September 19, 2025

## Product Update: 2026 CR-V SRS for EDR Software Update

Year	Model	Trim Level	VIN Range
2026	CR-V	LX, EX, and EX-L	Check the iN VIN status for eligibility.

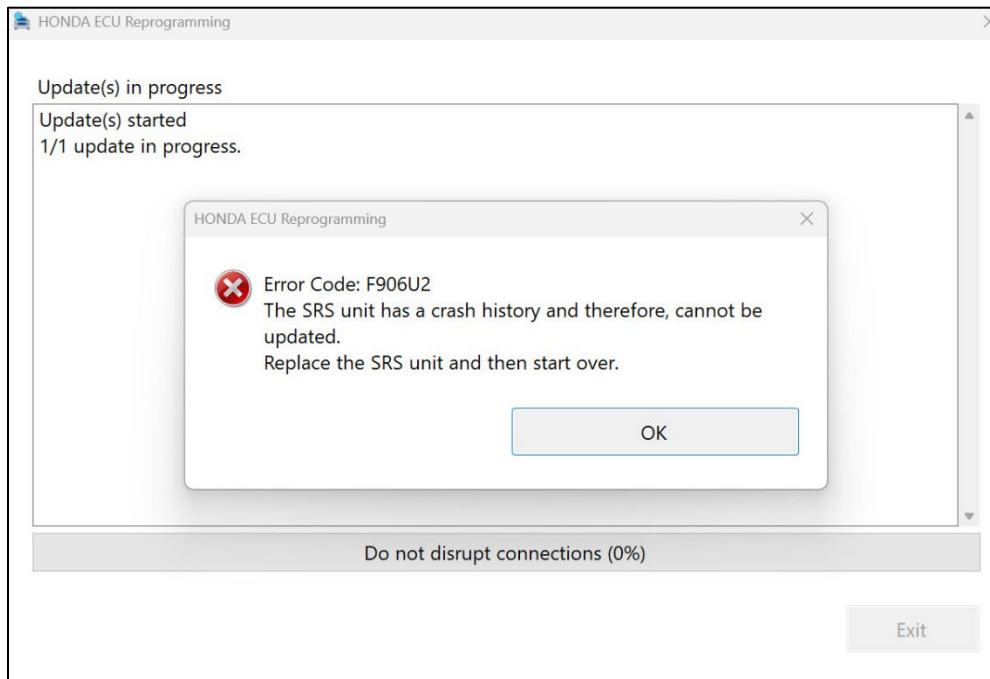
- If the SRS unit cannot be updated and displays the following error message, proceed to REPAIR PROCEDURE B.
- Order the parts required **ONLY** if the unit has failed to receive the update, a photo of the HDS screen failure **will be required** for warranty processing.
- Use the Parts Catalog and the VIN information to ensure correct parts replacement. Make sure the 3 ground bolts are ordered and replaced.
